ORANGE COUNTY WATER DISTRICT
18700 Ward Street
Fountain Valley, California 92708

ADDENDUM NO. 4
TO
CONTRACT DOCUMENTS
FOR
CITY OF SANTA ANA
PFAS TREATEMENT AT JOHN GARTHE RESERVOIR
CONTRACT NO. SA-2025-1
11/5/2025

CD0102

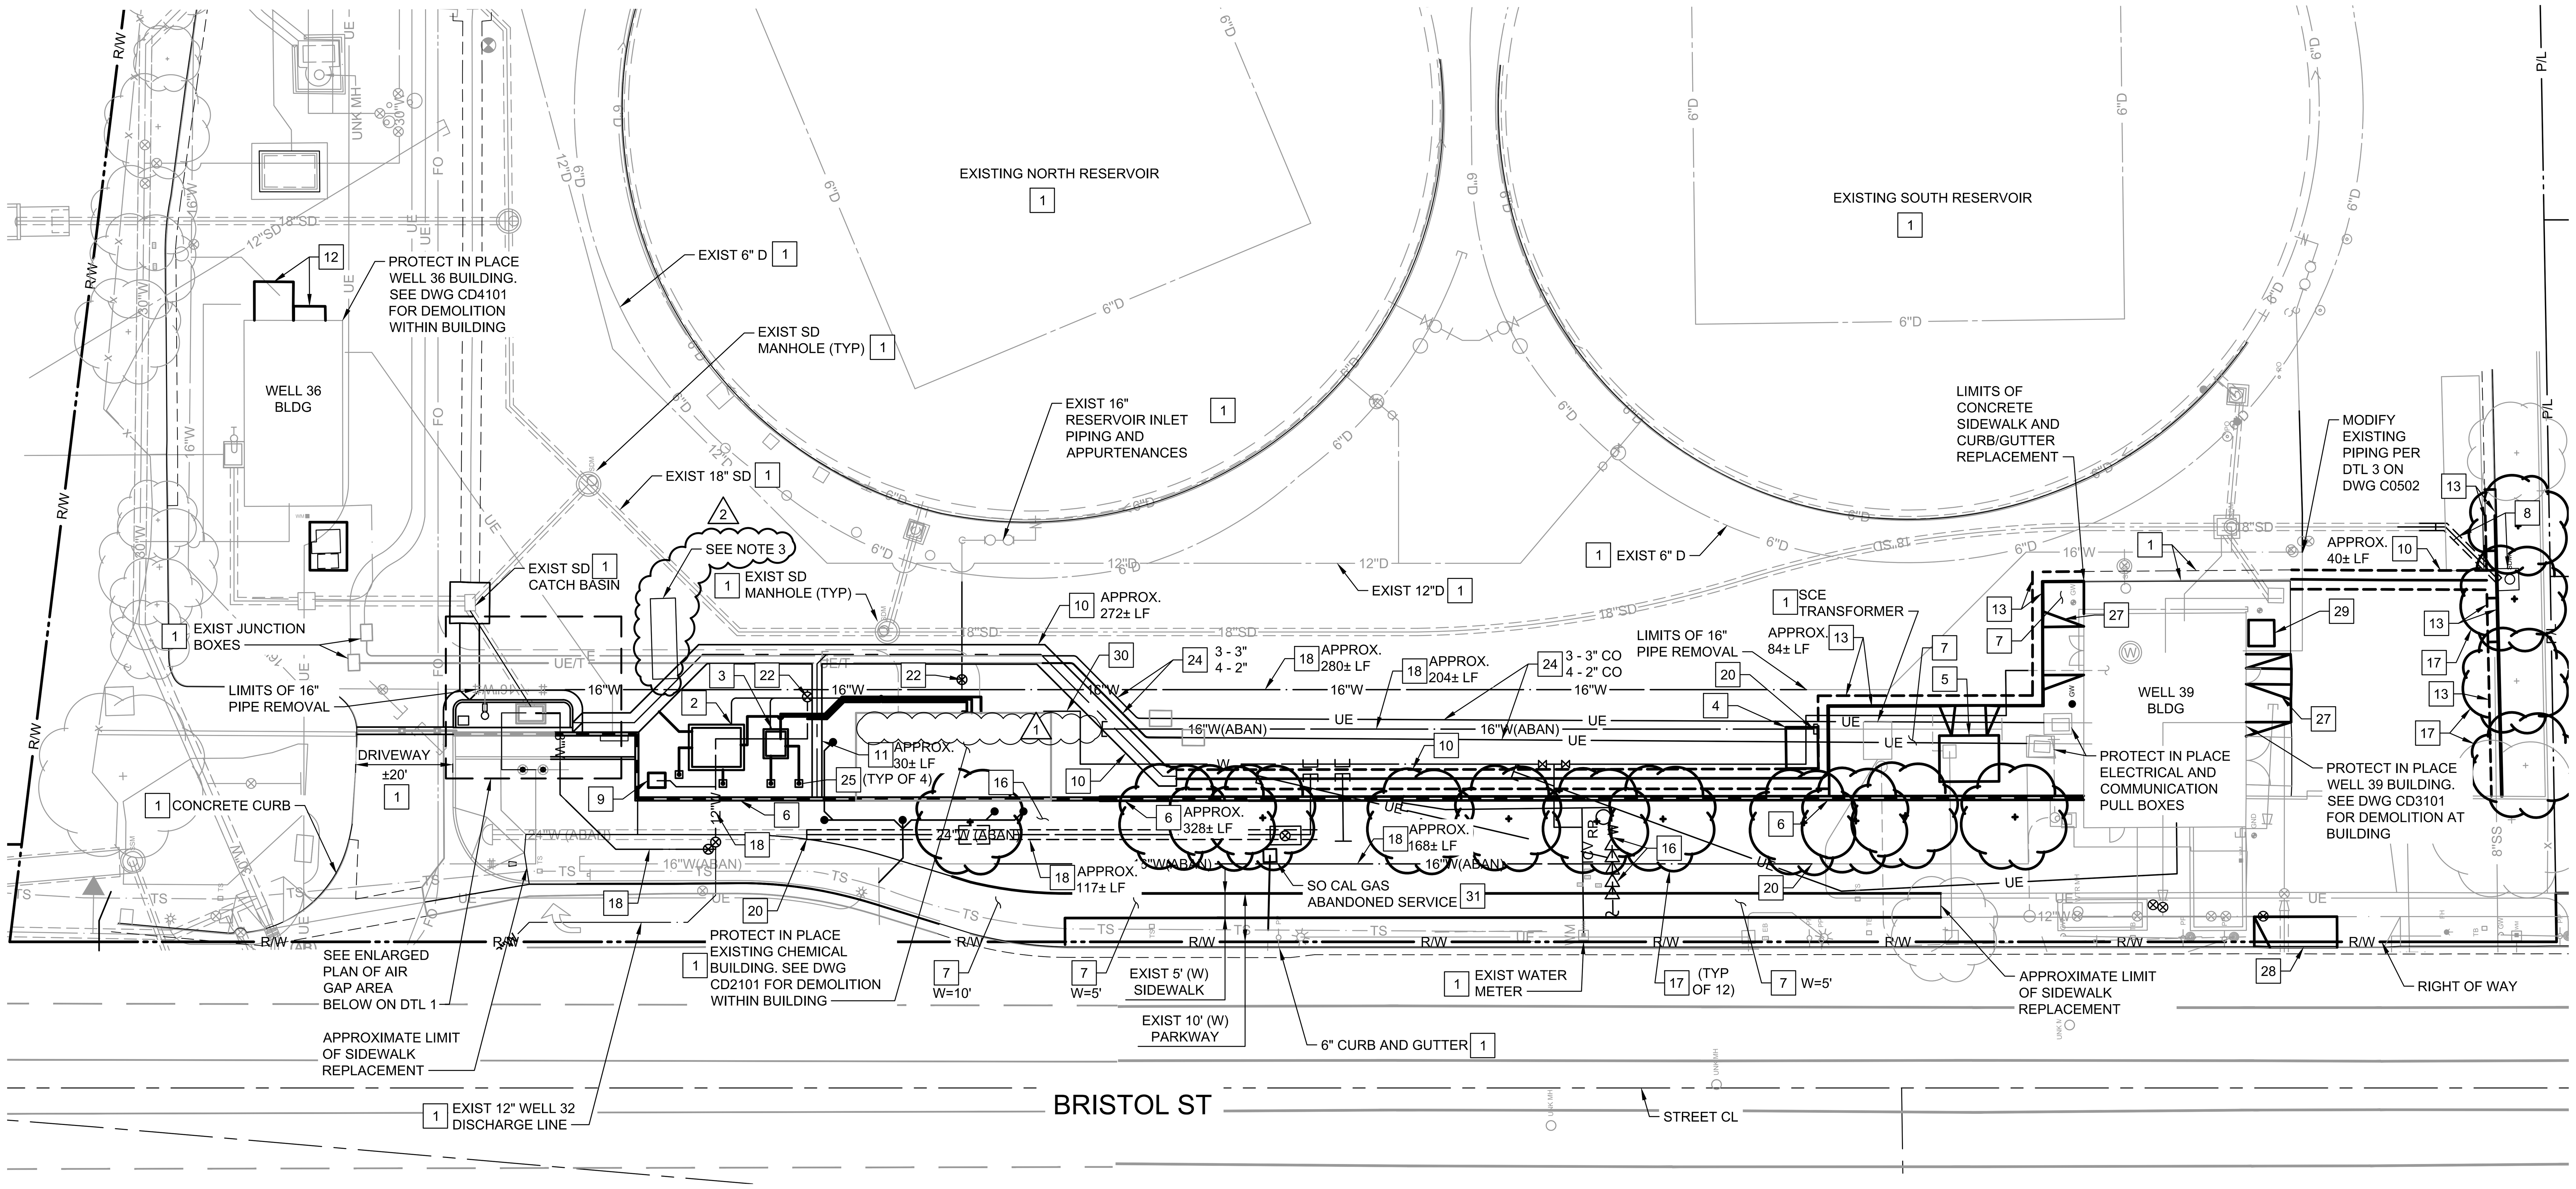
b. DWG CD0102

3. DWG CD0102 has been revised to include removal and disposal of existing concrete wellhead.

ORANGE COUNTY WATER DISTRICT
CITY OF SANTA ANA PFAS TREATMENT AT JOHN GARTHE RESERVOIR
HYDRO-GENERATOR AND WELL 39 PLAN

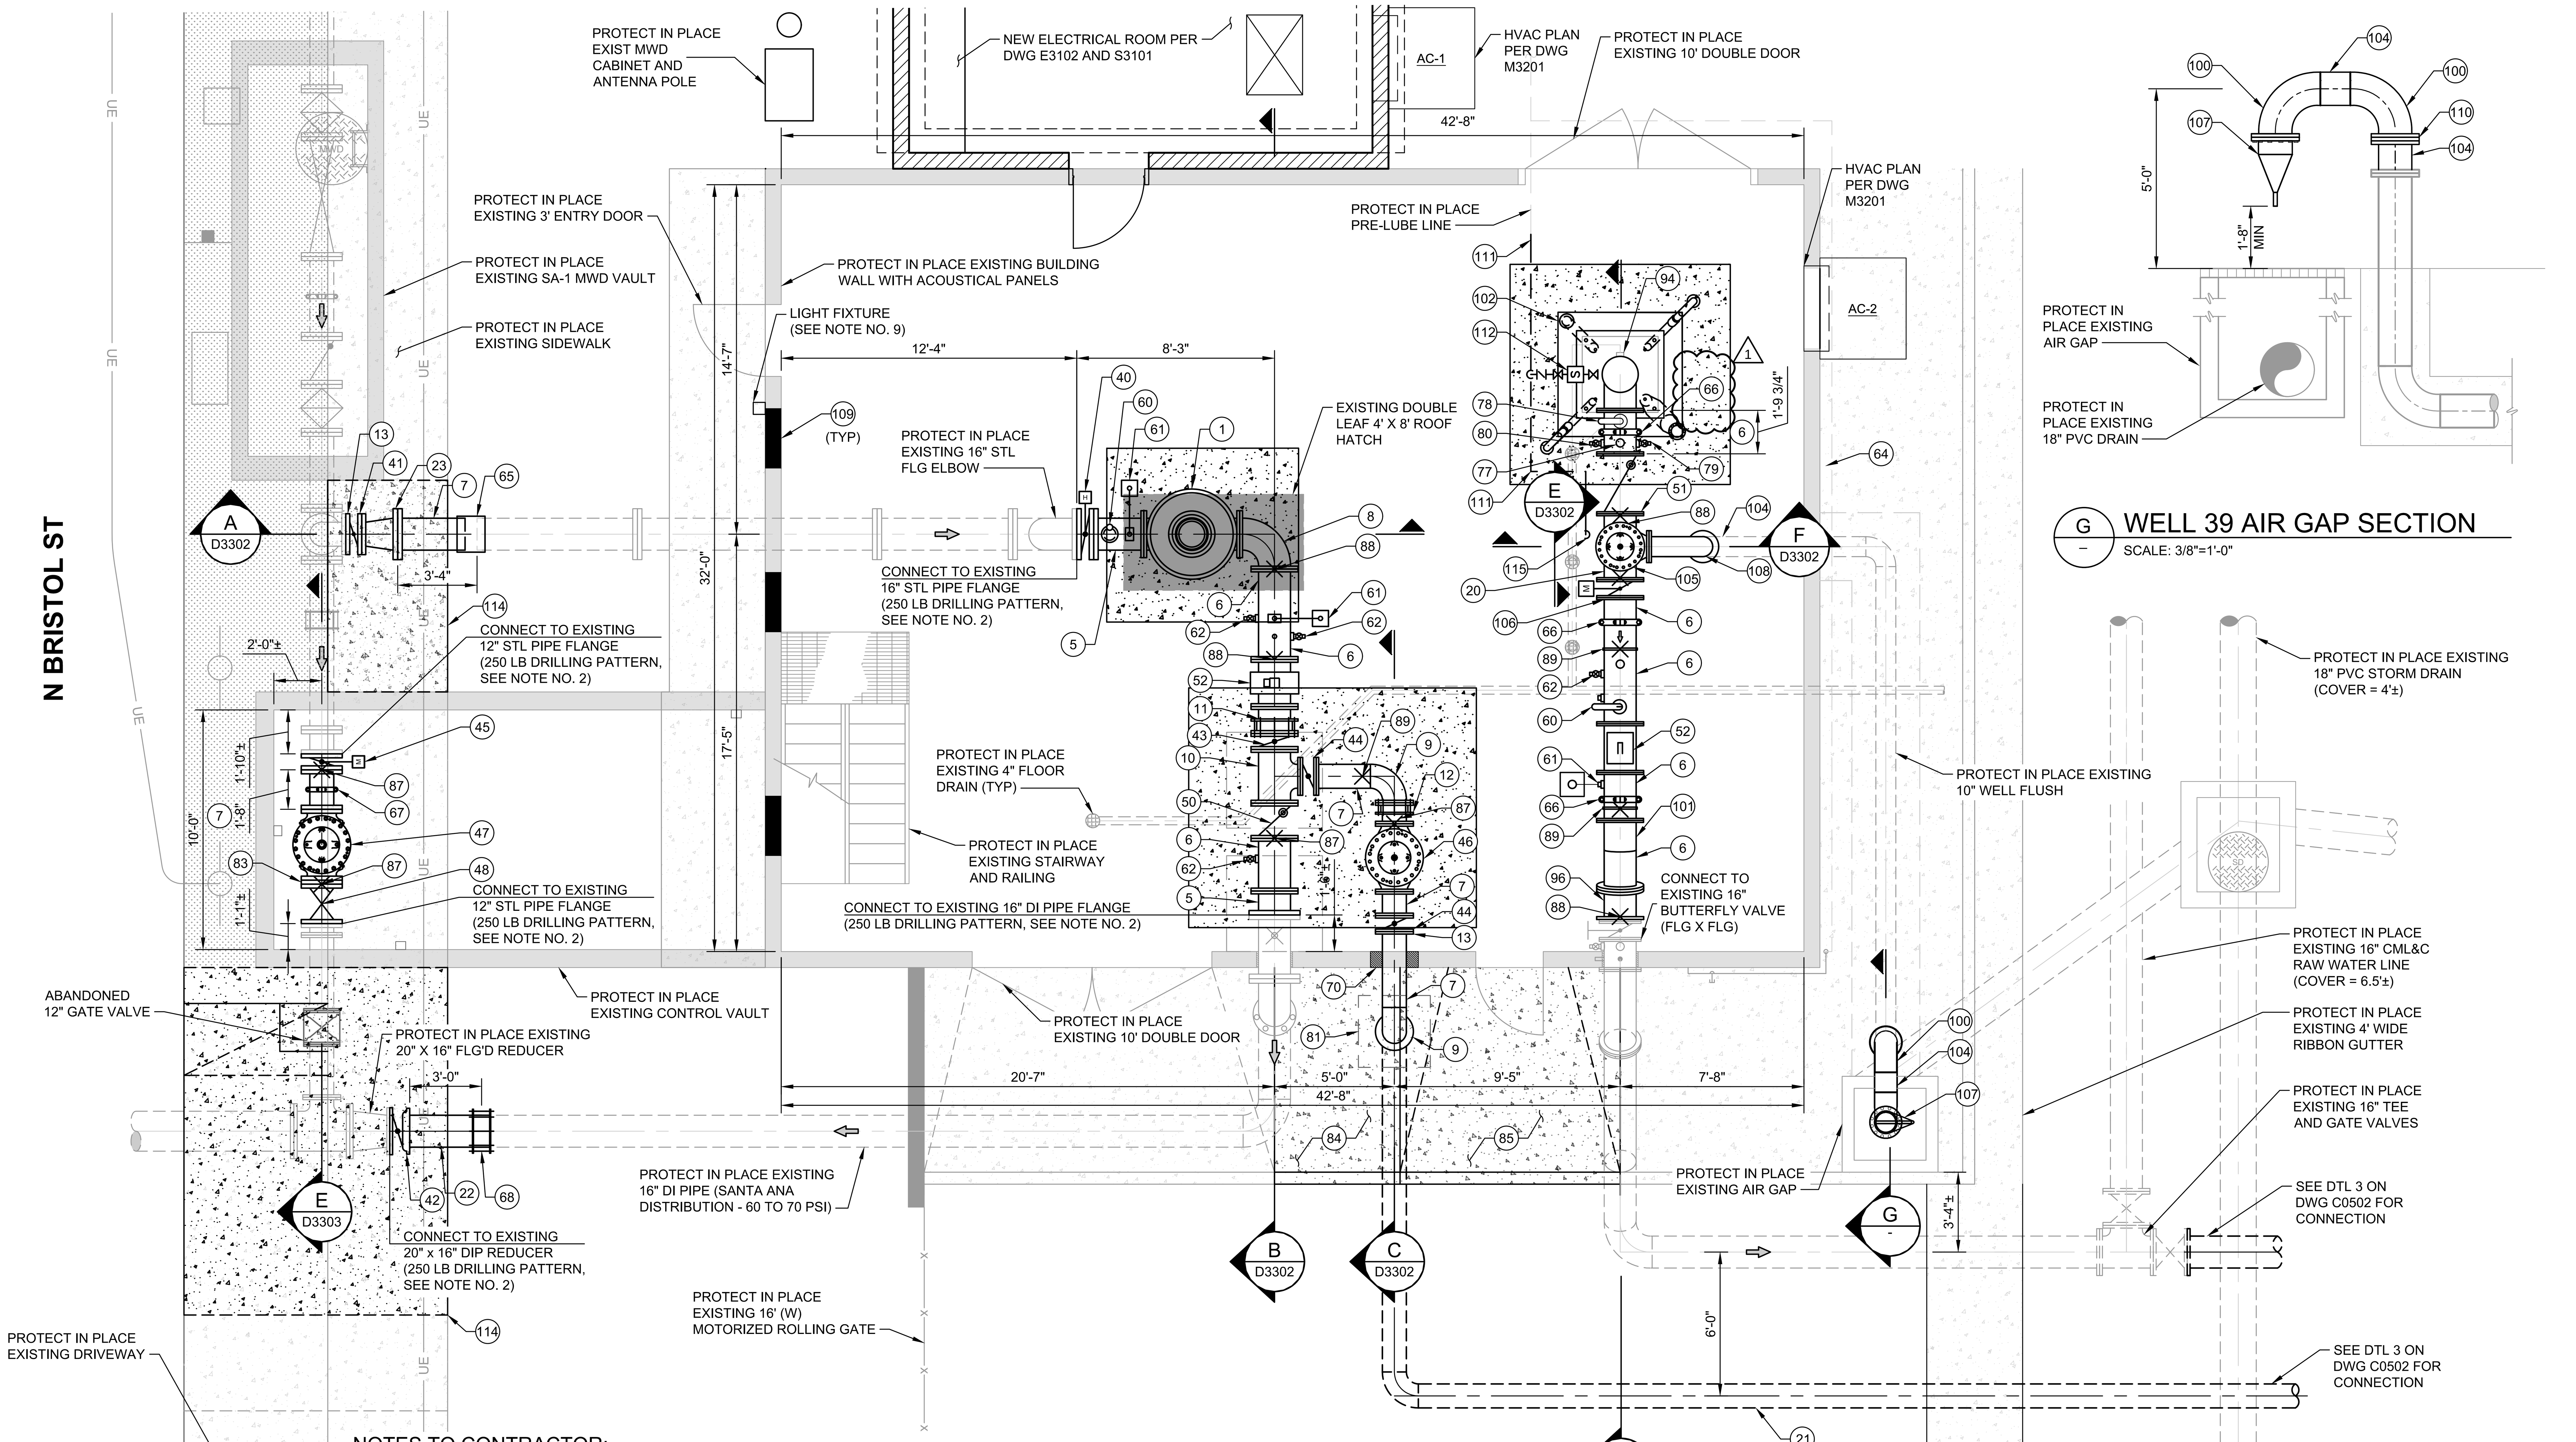
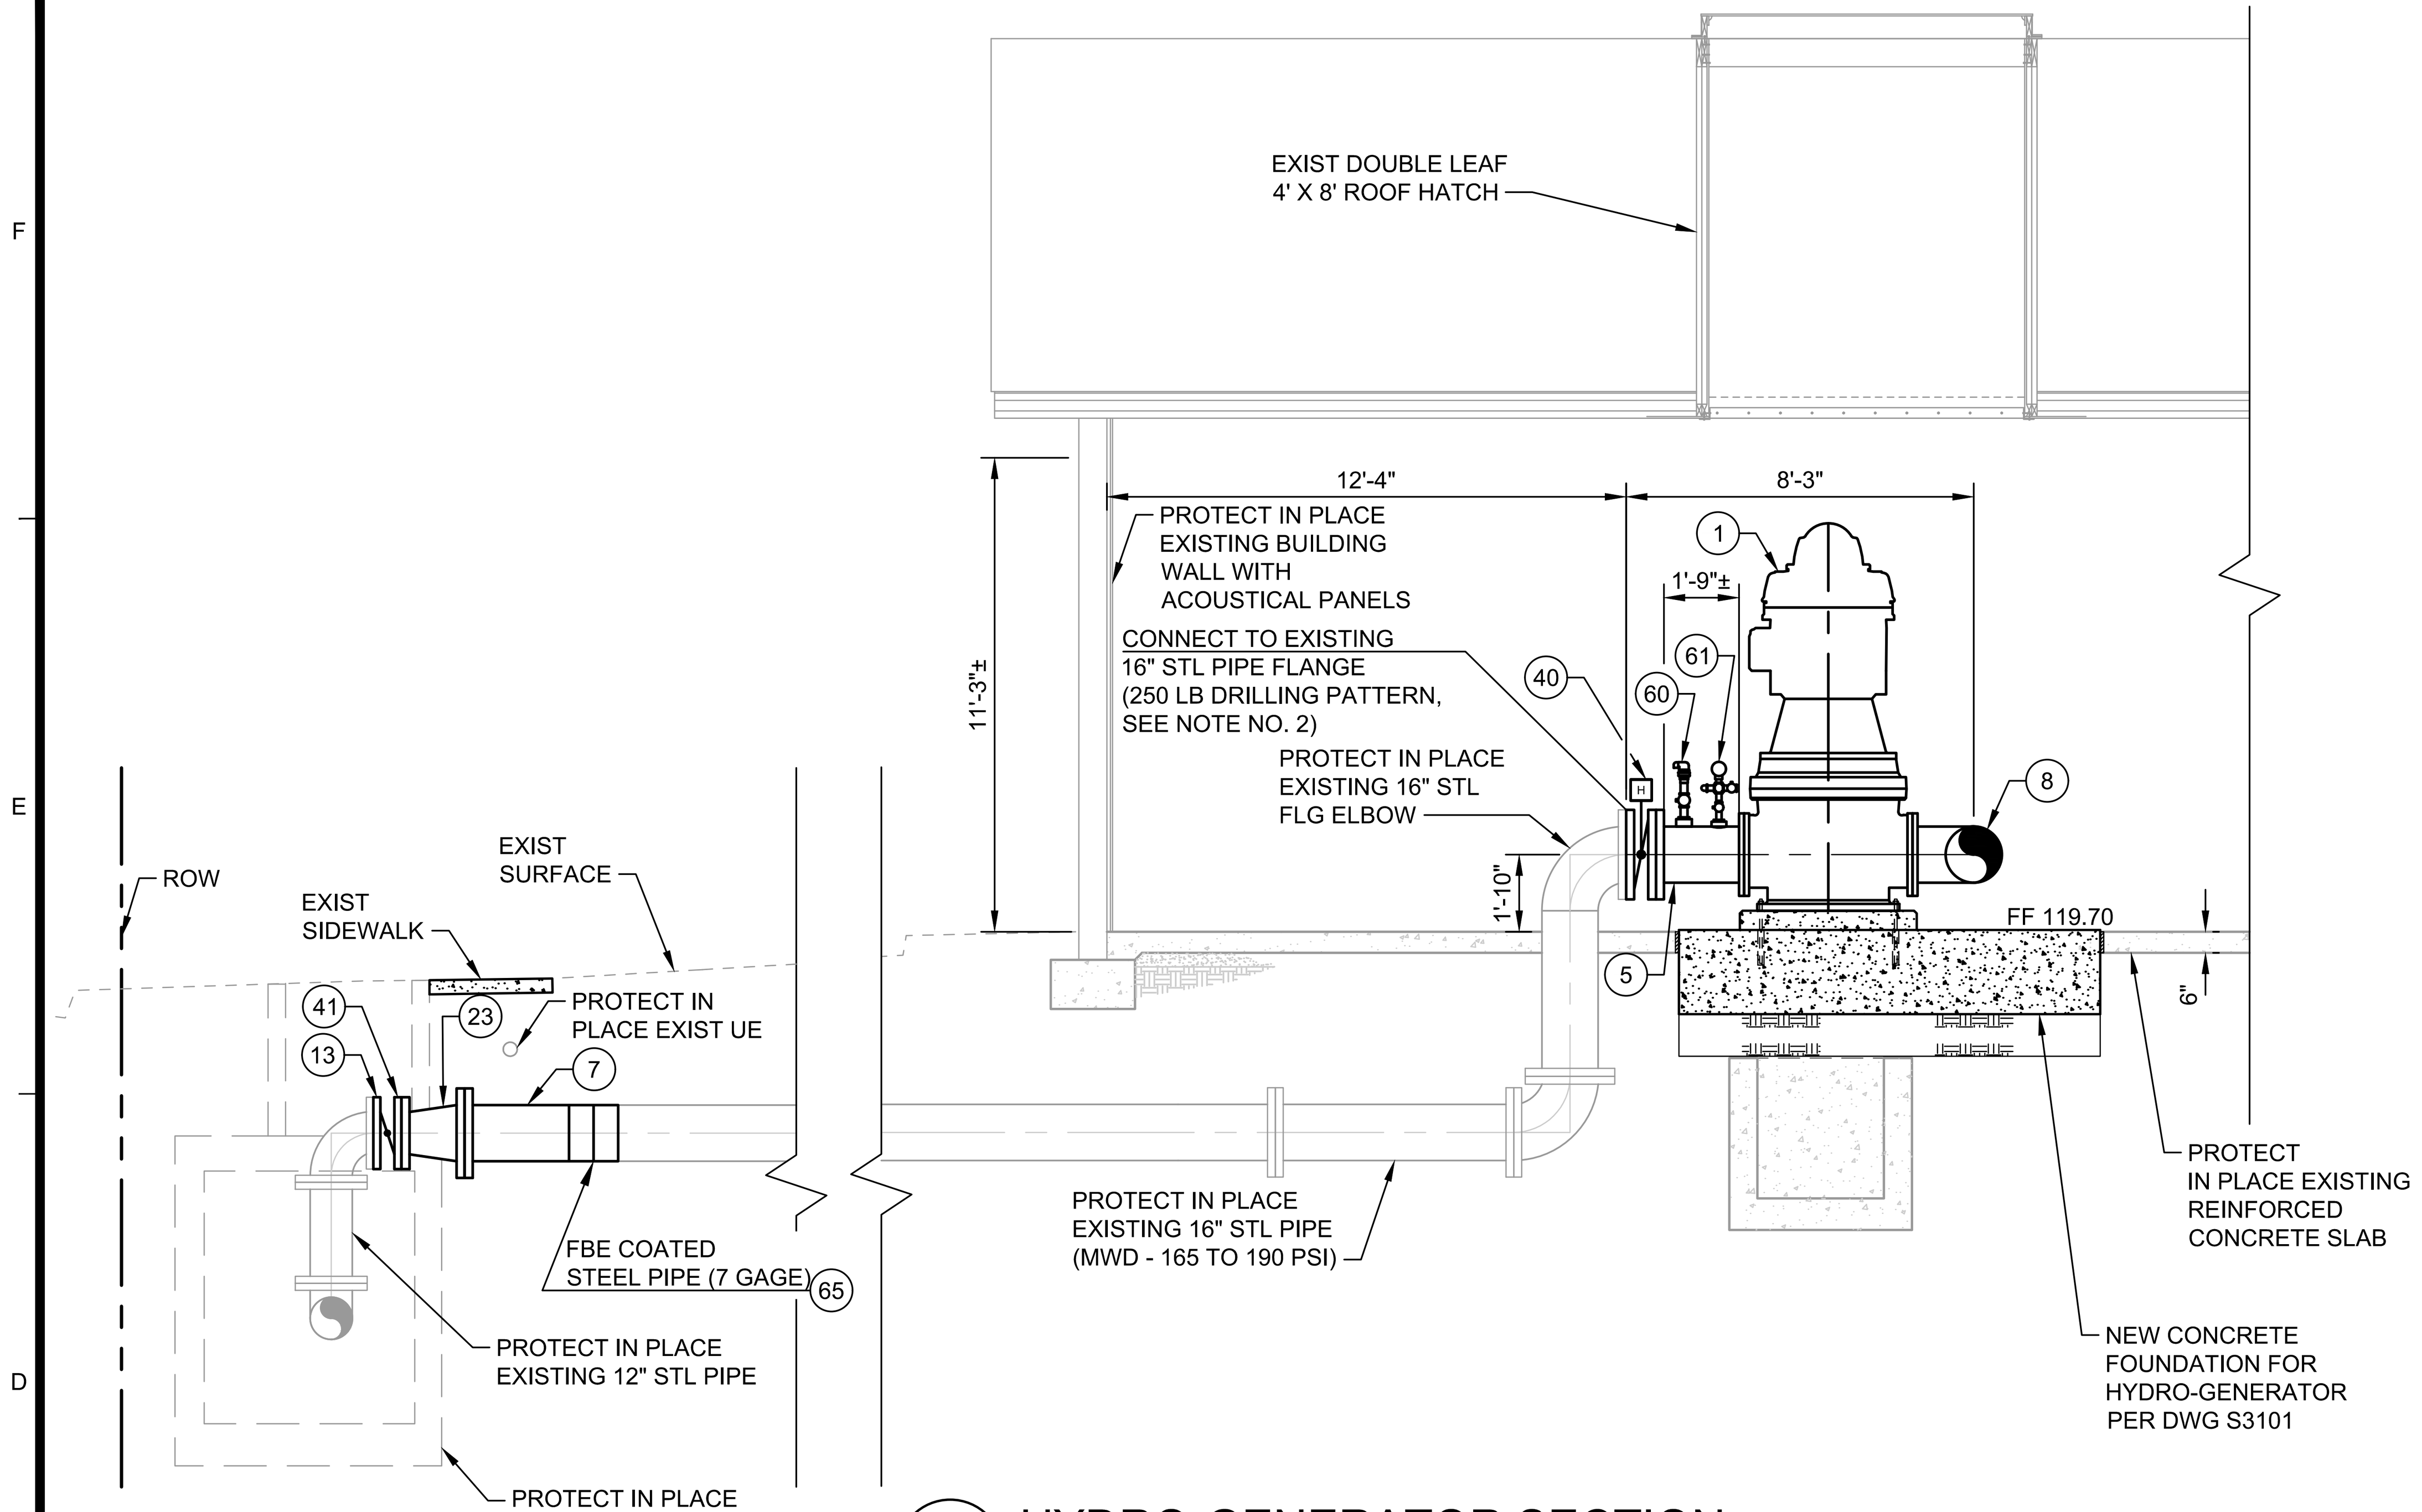
32	11. Please clarify what is intended to be entered into Bid Item #10 – Above Grade Pipe, as the other bid items in the IX area, OSHG building, Well building, Sand Filter, etc also state that they are to include the pipe.	Bid Item #10 is for all above grade piping that is not included in another specific bid item.
33	Drawing D0501 – Pre-Lube Assembly Backflow Preventer: Detail 8 on Drawing D0501 shows a backflow preventer in the pre-lube assembly. Since a backflow preventer already exists on the copper supply line, please confirm whether the additional backflow preventer is required.	Backflow preventer shown in detail is required - bid per plan.
34	• Drawing D0301 / D3302 – Coupling Type Clarification: Construction Note 68 on Drawing D0301 specifies a flexible coupling, while Construction Note 66 on Drawing D3302, Section D, indicates a grooved coupling at the same location. Please confirm which coupling type is correct.	Plan sheet D3101 has been revised to reflect Construction Note 66.

35	• Drawing D3101 – Port at 2" Air/Vac Assembly: On the Well 39 discharge piping shown in Drawing D3101, there is a port near the 2-inch air/vac assembly that is not labeled. Please confirm if this is intended to be a 1-inch flow meter test port.	This tap is a 2" spare pipe tap. Plans have been revised to show construction note 62.
36	Drawing D3101 / D3302 – Hydro Generator Pipeline Supports: Drawing D3101 shows three pipe supports on the 16-inch hydro generator pipeline, while Drawing D3302, Section B, shows only two supports. Please confirm the correct number and spacing of supports.	D3101 is correct - D3302 has been revised to reflect the three pipe supports.
37	Pipe Schedule: The bid documents (Construction Drawing, Specifications and Pipe Schedule) call for Schedule 80 PVC for the double containment carrier pipe, however, the construction notes calls for CPVC. Please clarify.	Construction notes will be updated for the sodium hypochlorite to call out PVC.
